RE: WASTEWATER SYSTEM IMPROVEMENTS
OUR HOME, INC.
HURON, SOUTH DAKOTA
SPN # M 15029

ADDENDUM NUMBER 1

PLAN SHEET 6 – DUPLEX GRINDER LIFT STATION DETAILS

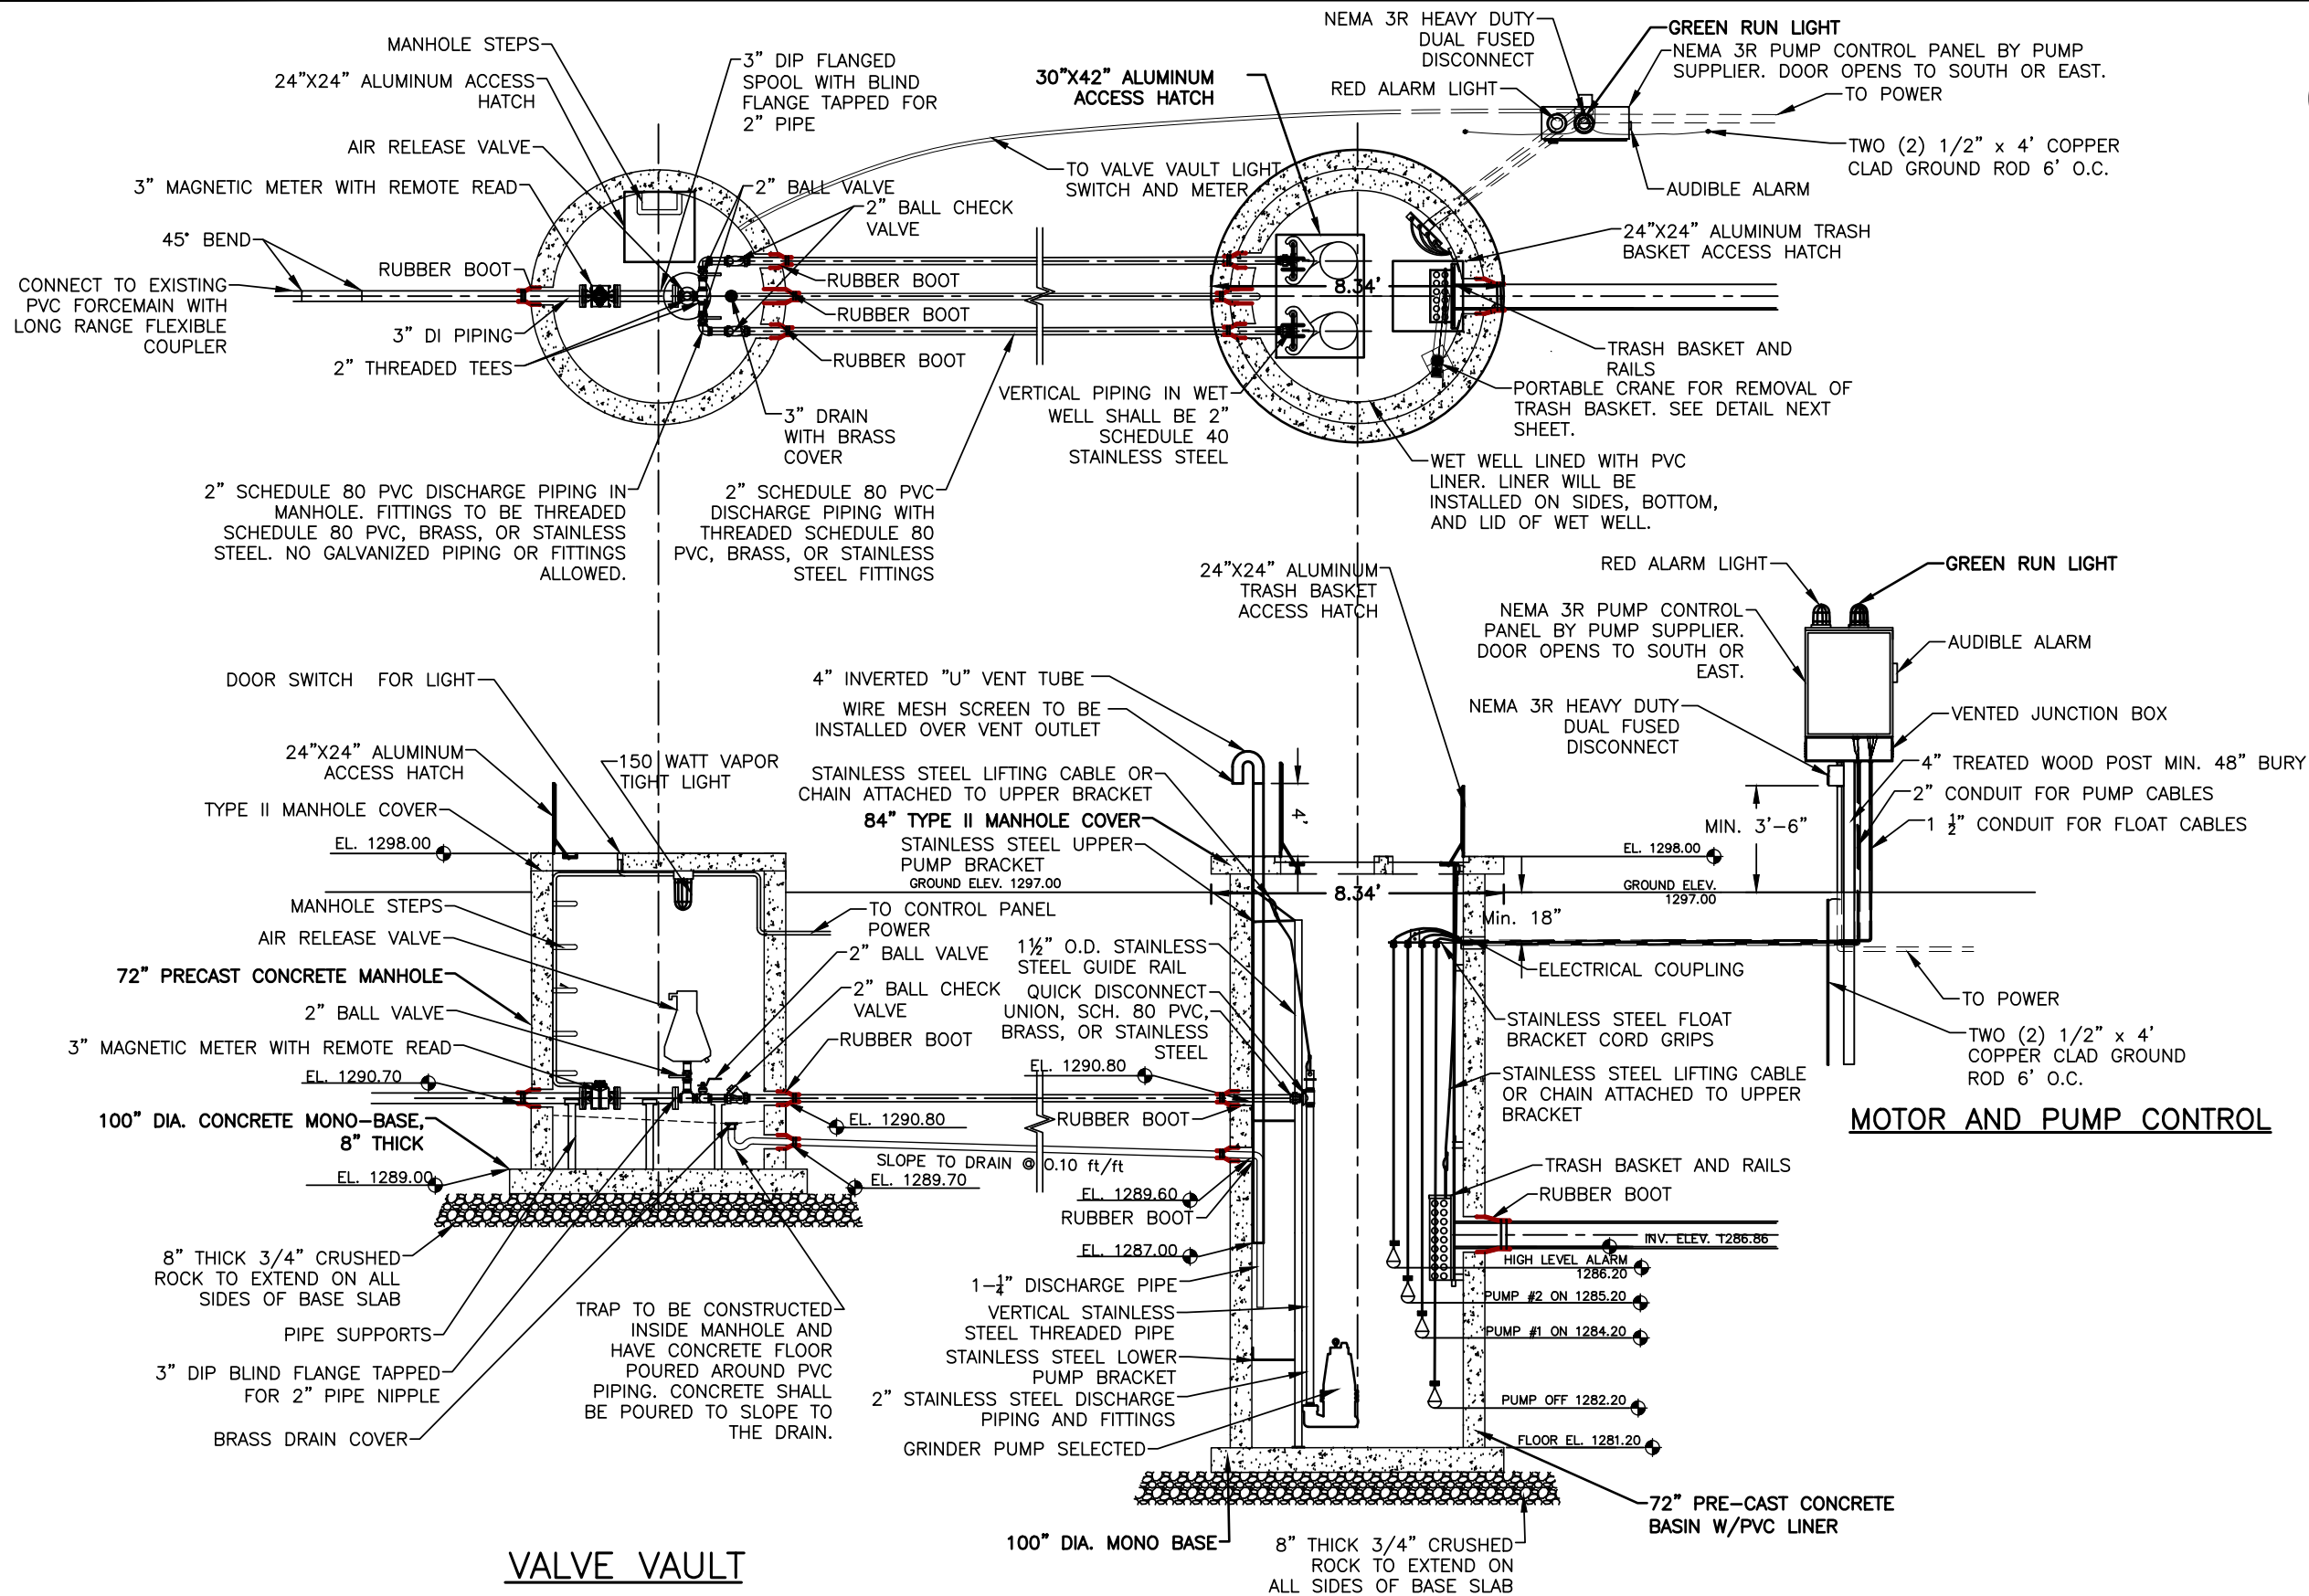
1. Diameter of wet well and valve vault was revised to 72-inches for the inside diameter of both structures
2. Type II cover on wet well revised to an O.D. diameter of 100-inches.
3. Wet well and valve vault bases were revised to an O.D. diameter of 100-inches.
4. Pump access door was revised to 30 inches x 42 inches.
5. Trash basket access door was revised to 12-inches x 24-inches.
6. A green run light was added to the control panel.
